# INNER WEST COUNCIL

## DEVELOPMENT ASSESSMENT REPORT

<b>Application No.</b>	DA 201700488.01
<b>Address</b>	44 – 46 Princes Highway, St Peters
<b>Proposal</b>	Section 4.55 (1a) Application to modify development consent no. 201700488, to remove condition 1a of the consent.
<b>Date of Lodgement</b>	29 June 2018
<b>Applicant</b>	David Macready
<b>Owner</b>	Angus Property & Development PTY LTD
<b>Number of Submissions</b>	Twelve (12)
<b>Value of works</b>	\$12,248,239.00
<b>Reason for determination at Planning Panel</b>	Application seeks consent to remove a condition previously imposed by the Inner West Local Planning Panel and number of submissions
<b>Main Issues</b>	Overshadowing, Visual outlook, Character of Development
<b>Recommendation</b>	Approval

Picture 1 – Floor Plan - indication of Building B elements required to be deleted by condition 1a of the consent.

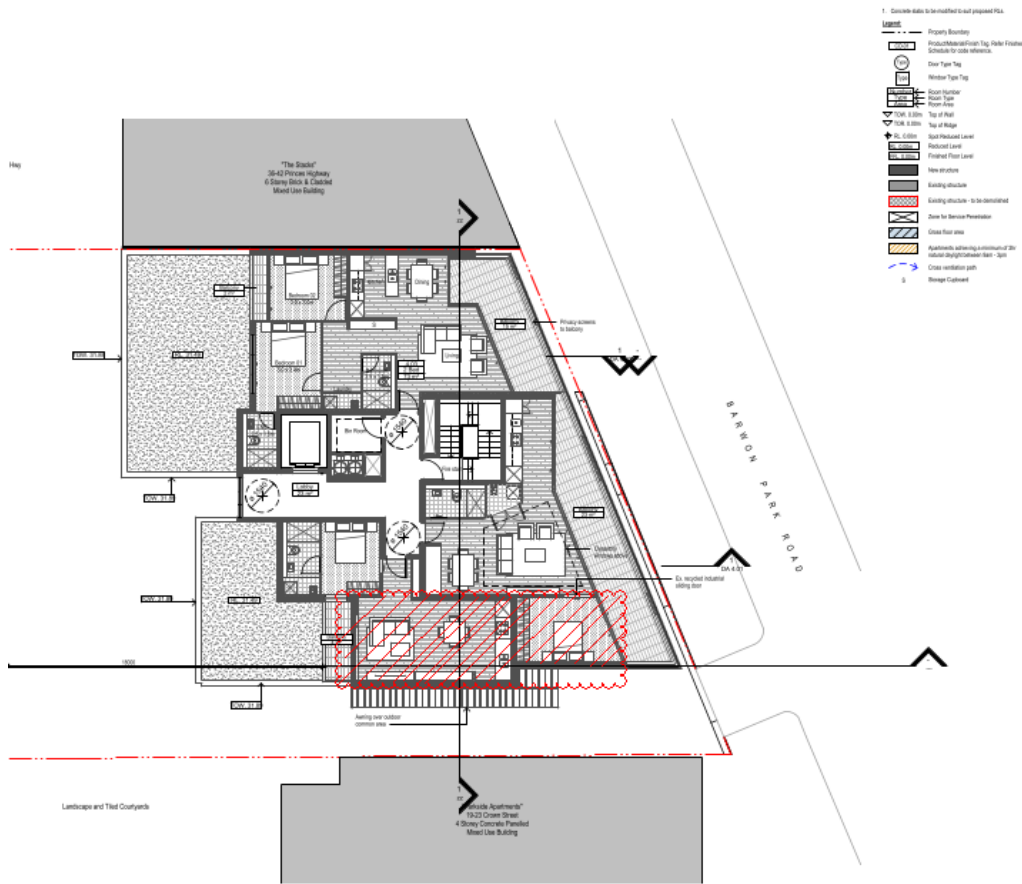
- 1a. *Prior to lodging any Construction Certificate application amended plans are to be submitted to and approved by Council's Development Assessment Manager indicating the following design changes:*
  - (i) *The southern (side boundary setback of the upper level of Building B being increased with the deletion of the living room and dining room of unit 4.01 and the deletion of the bedroom of unit 4.02*
  - (ii) *The remainder of the dwellings 4.01 and 4.02 being amalgamated to form one dwelling (i.e the upper level of Building B will contain a total of 2 dwellings).*
  - (iii) *The newly created setback area is to be maintained as non-trafficable roof or a passive green roof. Any new windows shall have a minimum sill height of 1.6m meters above floor level.*

authority to remove the condition from the consent. Pictures 1, 2 and 3 below detail on plan what elements of Building B are required to be removed by condition 1a.

Picture 4 - Non-compliance with overall heights shown in light orange, portion of the development subject to this modification application has been highlighted with a red cloud.

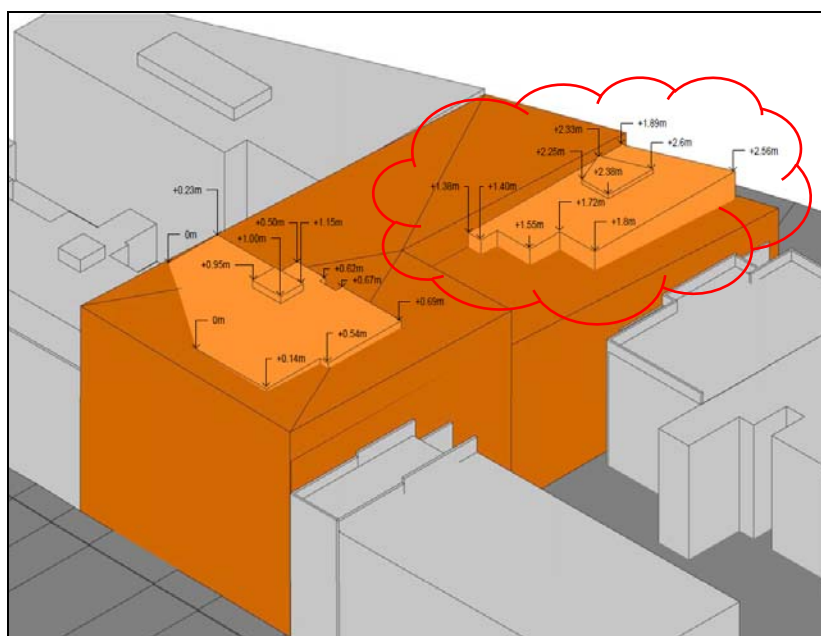
A maximum building height of 17 metres applies to the property known as 3 Barwon Park Road (portion of the development subject to the current modification application) under Clause 4.3 of MLEP 2011. Should the modification application to remove design change condition 1a be supported then highest point of the building on No. 3 Barwon Park Road will be 19.6 metres which results in a variation of 2.6 metres or 15.2%.

The current application has been lodged as a 4.55 modification, as such the applicant is not required to submit a clause 4.6 objection to vary development standards.

Picture 5 – Extent of shadow cast by height variation detailed in orange – image to the left is solar access for neighbouring roof top terraces at 9am, image to the right is solar access for neighbouring roof top terraces at 10am

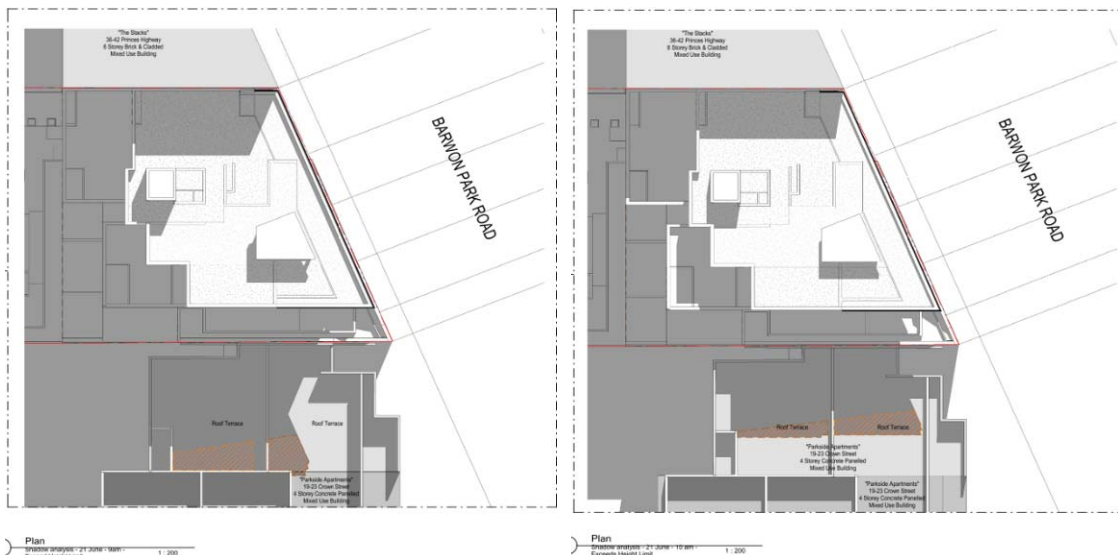
As detailed within the pictures below the removal of condition 1a results in a further loss of solar access to the roof top terrace of the neighbouring unit 29 at 9am. By 10am the terrace obtains a significant proportion of the space with direct solar access and by 1pm the roof top terrace enjoys almost full solar access, this is continued for 2pm. At 3pm a portion of the terrace is overshadowed however this overshadowing results from the balustrading of the terrace and other portions of the approved development.

Under section 2.7.3 of the 2011 Marrickville DCP developments must ensure a minimum of two hours solar access between 9am and 3pm on 21 June for neighbouring principle areas of open space. The shadow diagrams indicate that the roof terrace of the neighbouring unit 29 will continue to receive solar access over a minimum of 50% of the total area between 11:00am and 3:00pm, thus complying with Council’s controls. The extent of overshadowing caused by the portion of the development that varies from the height development standard does not significantly contribute to the overshadowing.

In this instance continuation of condition 1a is expected to result in minimal solar access improvements to neighbouring roof top terraces and is recommended for removal.
